SERVICE INSTRUCTION

RUNNING MODIFICATIONS ON ROTAX® ENGINE TYPE 912 AND 914 (SERIES) SI-25-1997

Running modifications on ROTAX® engine type 912 and 914 (series).

Bild / Fig. 2

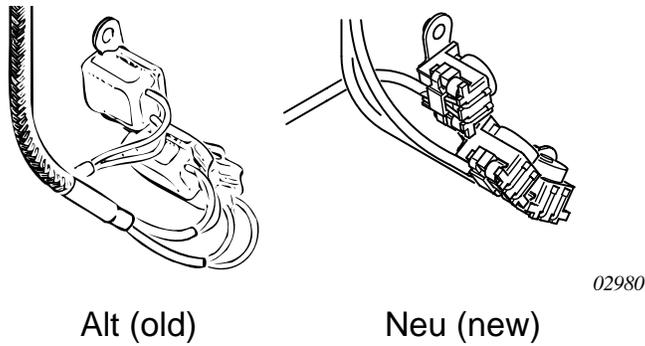
3.7) Introduction of a new O-ring as replacement part on the choke valve

(see fig. 2)

On the 912/914 carburetor parts list the O-ring part no. 850 510 has been replaced by O-ring 950 420. But consider when ordering parts, that the O-ring 850 510 remains in the list for the spare parts service of the electric starter 912/914.

O-Ring TNr. **850 510**
Identifizierung: schwarz
O-ring part no. **850 510**
Identification: black colour
Alt (old)

O-Ring TNr. **950 420**
Identifizierung: grün
O-ring part no. **950 420**
Identification: green colour
Neu (new)
